TAPU NOA PRINCIPLES | PLAN ANALYSIS OF RA/RC/RG

Design Comments/Queries:

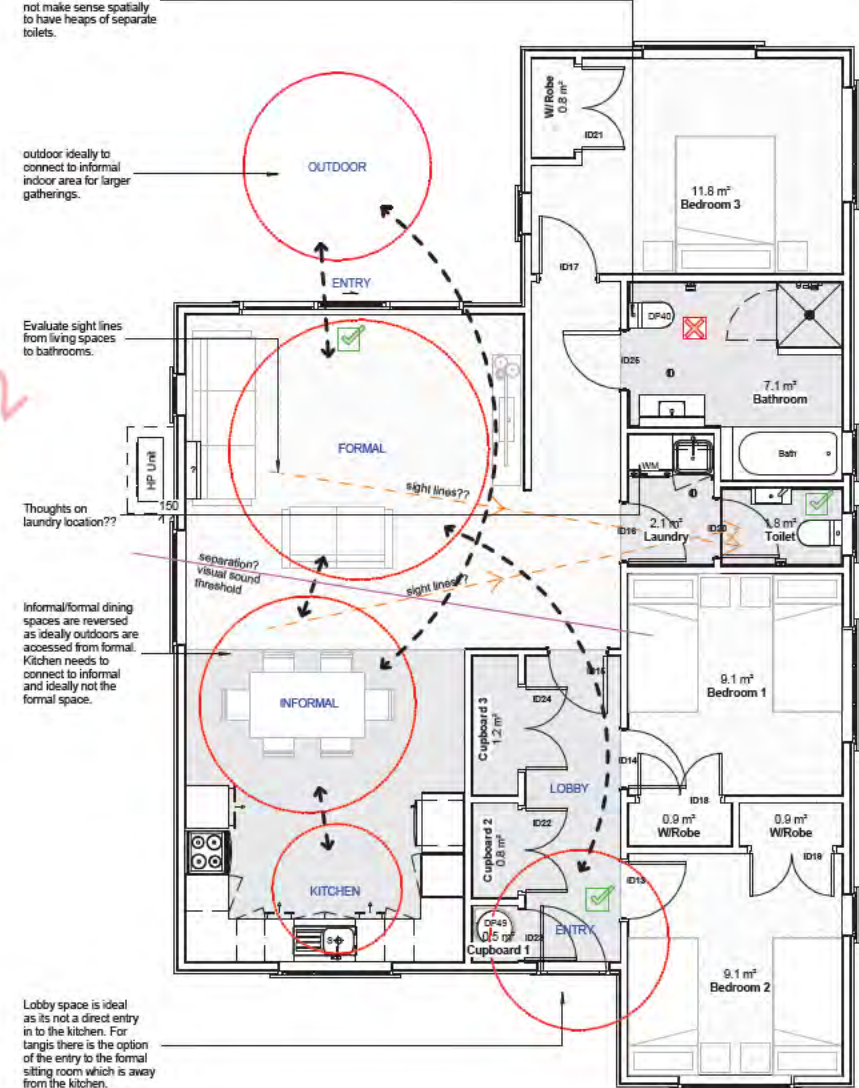
Laundry in bathroom space is not an ideal location.

2bedrooms + require separate toilets.

Evaluate sight lines from living spaces to bathrooms.

Is the entry defined enough or too direct into the informal space?

Would separation be required for 2bedroom plans?

Is one combined toilet ok? For the houses with two or more toilets, it does not make sense spatially to have heaps of separate toilets.

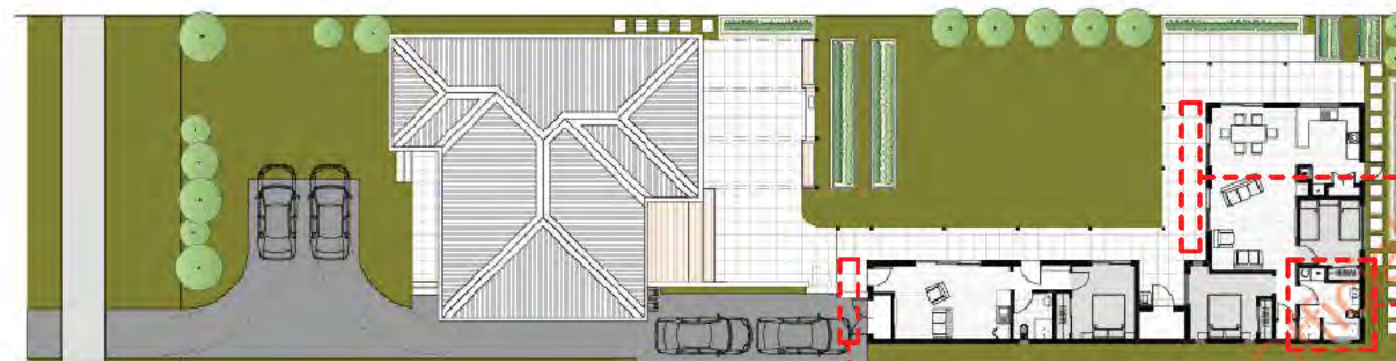
Outdoor ideally to connect to informal indoor area for larger gatherings.

Evaluate sight lines from living spaces to bathrooms.

Thoughts on laundry location??

Informal/formal dining spaces are reversed as ideally outdoors are accessed from formal. Kitchen needs to connect to informal and ideally not the formal space.

Lobby space is ideal as its not a direct entry in to the kitchen. For tangis there is the option of the entry to the formal sitting room which is away from the kitchen.

- Passive surveillance could be reduced with a bedroom facing toward the street?
- Defined entry is not easily identified from this building elevation. What are the ideals in terms of passive surveillance - are living rooms appropriate instead of kitchen windows?
- Toilet is combined with bathroom in a floorplan with more than 2 bedrooms.
- There is little engagement with the street from the elevation of this building.
- Is this a suitable entry straight into the living room? There is no formal lobby space.

Combined W/C in bathroom - is this suitable for number of bedrooms?

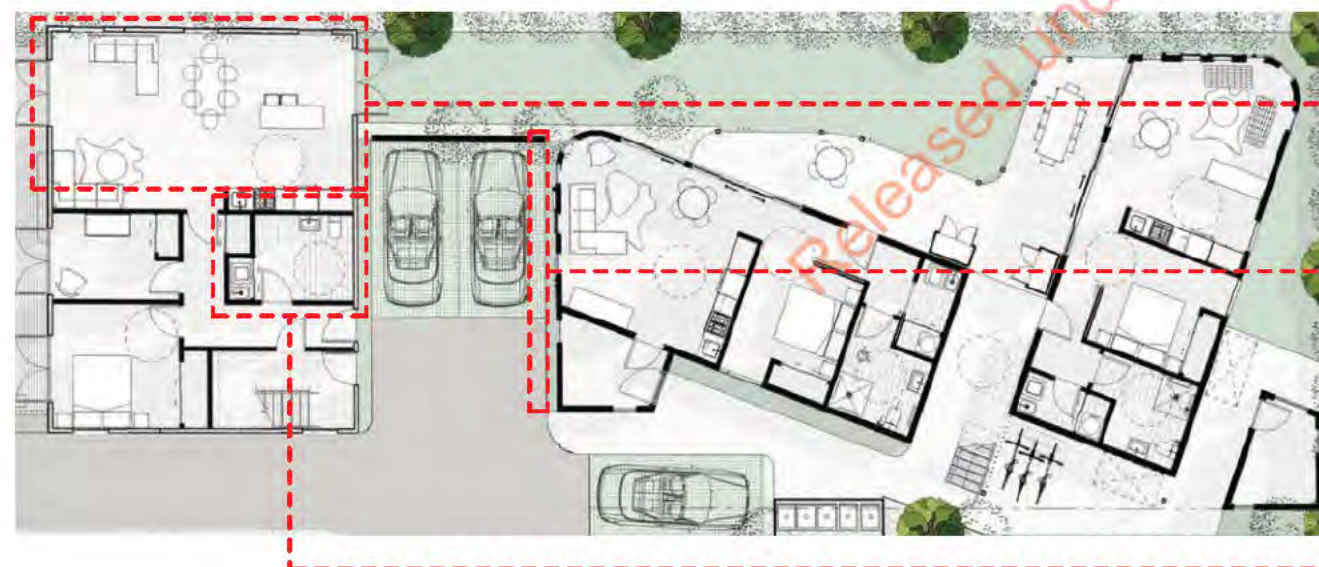
Combined W/C in bathroom - is this suitable being one bedroom on this floor?

- No clearly defined entry from front face of building. Clarify what is deemed suitable for CPTED principles.
- Combined W/C and laundry in bathroom - is this suitable for number of bedrooms? No separated 'clean zone' for laundry.
- There is little engagement with the street from the elevation of this building.

- Combined K/D/L - outdoor area accessed off of kitchen. Clarify how this is suitable for tangi proceedings and how the formal/informal spaces work with the kitchen.
- No clearly defined entry from front face of building or pathside of building. Clarify what is deemed suitable for CPTED principles.
- Combined W/C and laundry in bathroom - is this suitable for number of bedrooms? No separated 'clean zone' for laundry.
